## Review of Coastal Hazards and Coastal Sensitivity Area at Te Akau South

Waikato District Council (“WDC”) have engaged Tonkin & Taylor Ltd. (“T+T”) to undertake a review of the Coastal Hazards and Coastal Sensitivity Area at Te Akau South contained in Appendix 2 of the report titled Waikato District Coastal Hazards - Response to submission on Waikato District Plan Stage 2: Coastal Hazard Area Maps, by Bronwen Gibberd - 4D Environmental Ltd and Jim Dahm - Eco Nomos Ltd (March 2021).

Appendix A: Te Akau South Hazard Assessment  
including T+T comments

# Appendix 2: Review of Coastal Hazards and Coastal Sensitivity Area at Te Akau South

Figure 1 Extent of the mapped high risk coastal erosion hazard area and coastal sensitivity area for Te Akau South

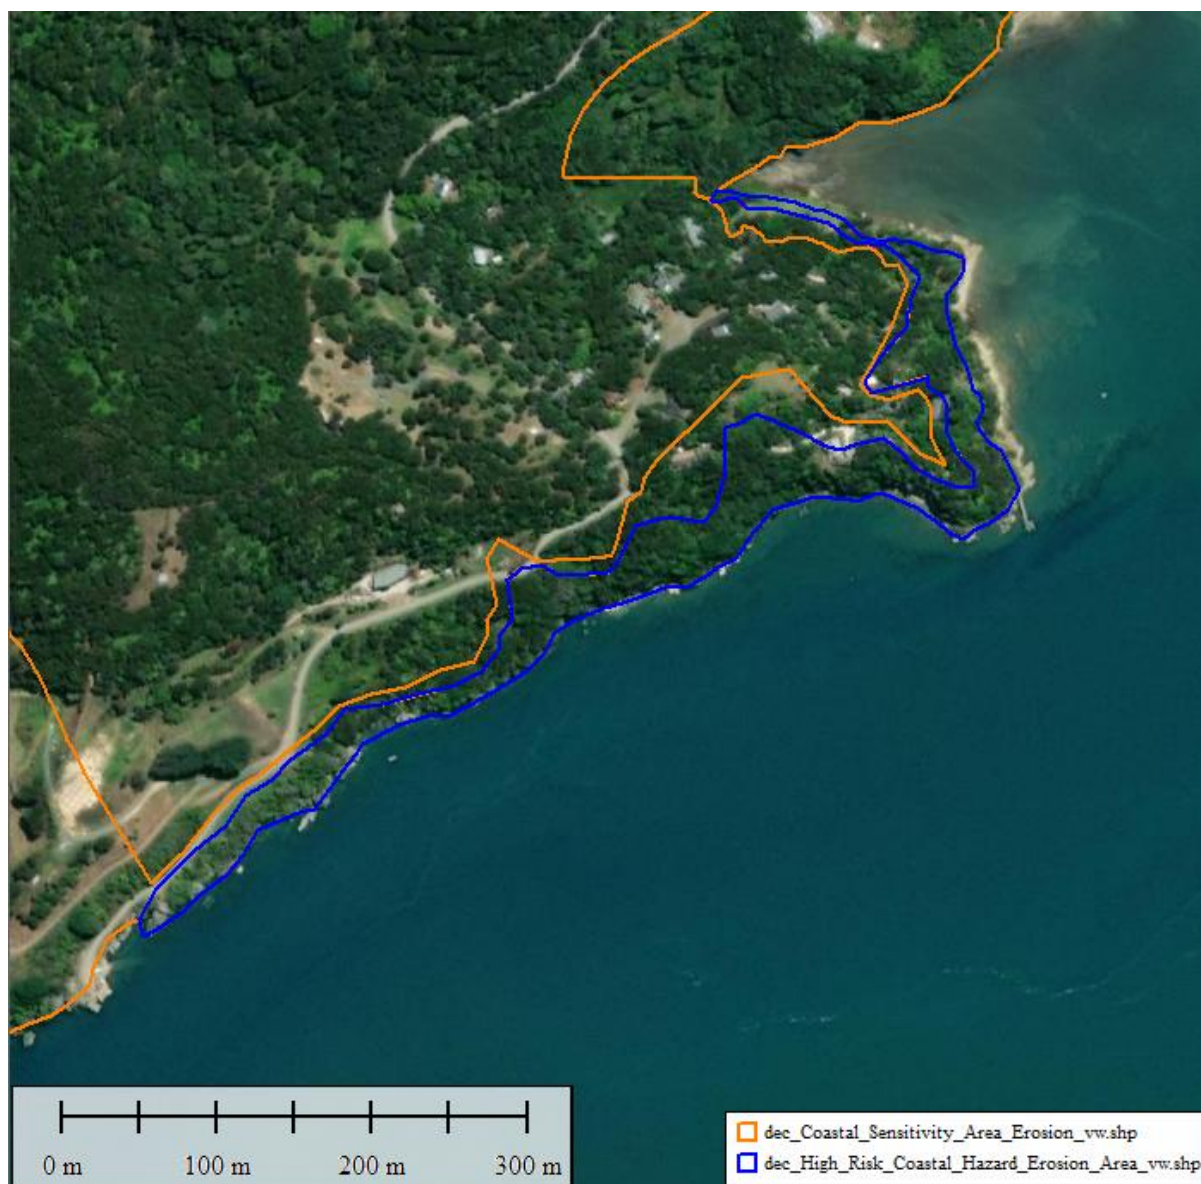
- Mapping has been undertaken by projecting an assumed slope from either the current or an assumed future toe position. This is generally best practice and appears to have been undertaken carefully, although will be dependent on the quality and accuracy of topographic information utilised. Little information is provided on the source or accuracy of this data.
- The only query regarding mapping that has been raised is around the flatter slopes assumed adjacent 2E Ryan Road where the mapped high risk hazard line appears to project well inland compared to adjacent sections.

Figure 54: Cross shore profile in the vicinity of the recent land slip (elevation data pre-dates the landslip). Blue and orange arrows indicate the landward boundary of the High Risk Coastal Hazard Area (Erosion) and Coastal Sensitivity Area (Erosion) respectively.

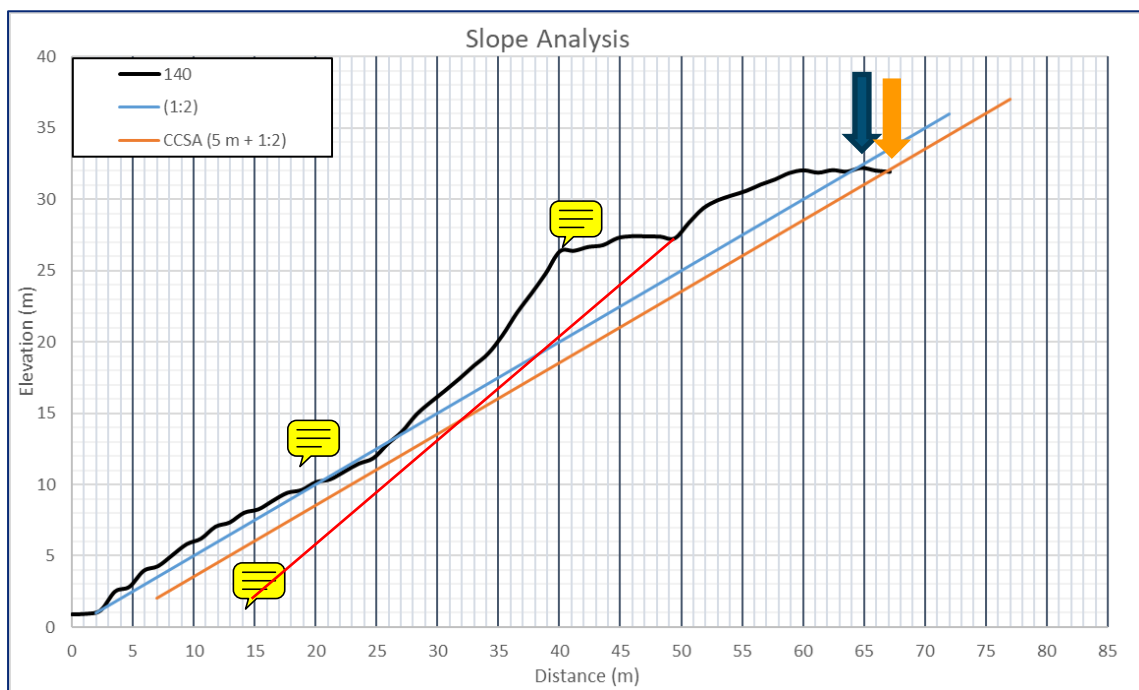
- The coastal edge shown within Figure 54 looks like it may have already experienced an (older) landslip. If so, it could be considered using the same 1(V):1.5(H) slope as adjacent sections but from the location of the assumed rock toe (beneath the landslip).

Figure 58: Revised High Risk Coastal Hazard Area (Erosion) and Coastal Sensitivity Area (Erosion) at Te Akau South (Section 4).

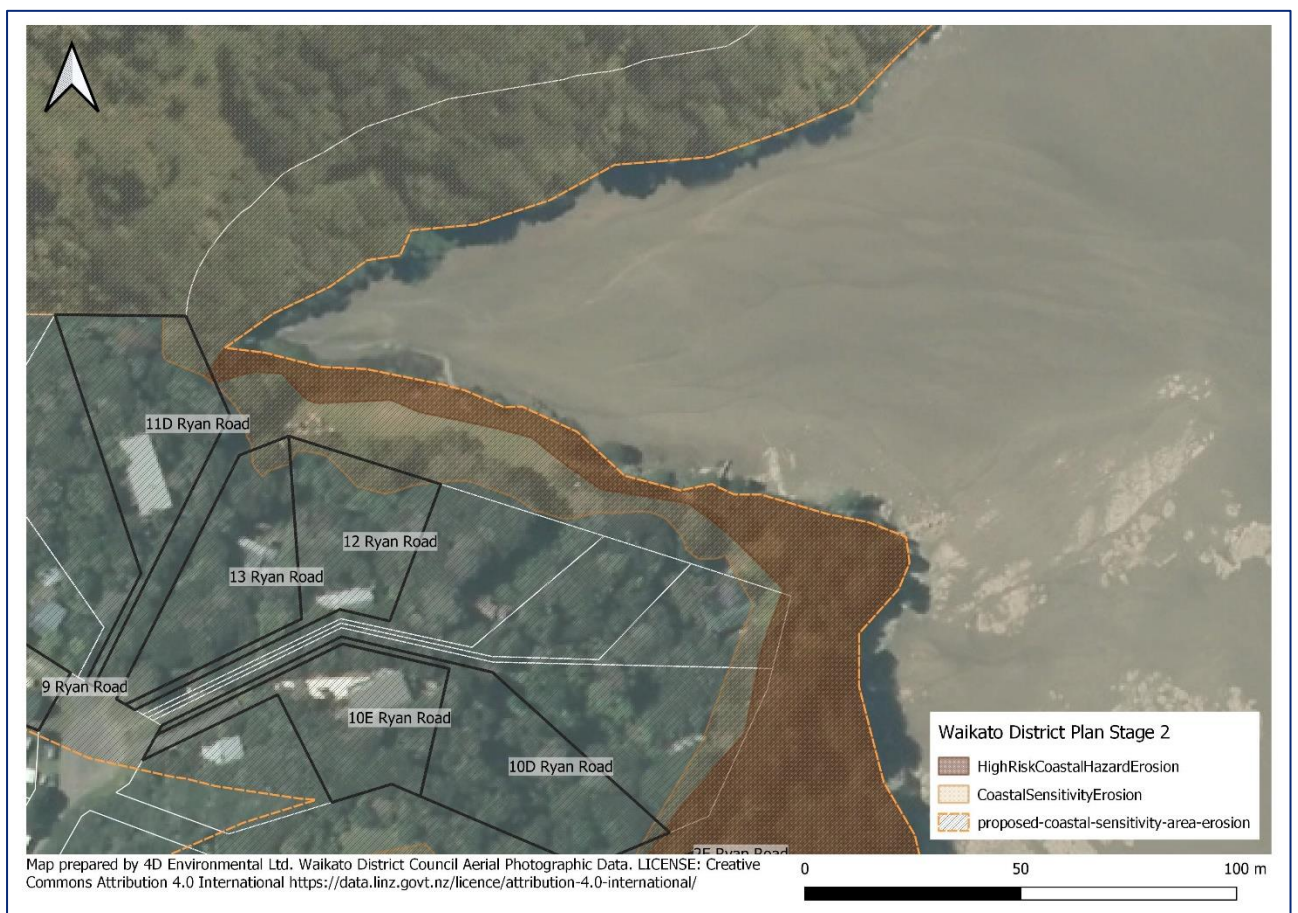
- We appreciate the difficulties assessing future erosion rates in the sheltered Section 4 environment but using an offset distance or extending to the toe of the cliff rather than to a contour might be more appropriate for the coastal sensitivity area.
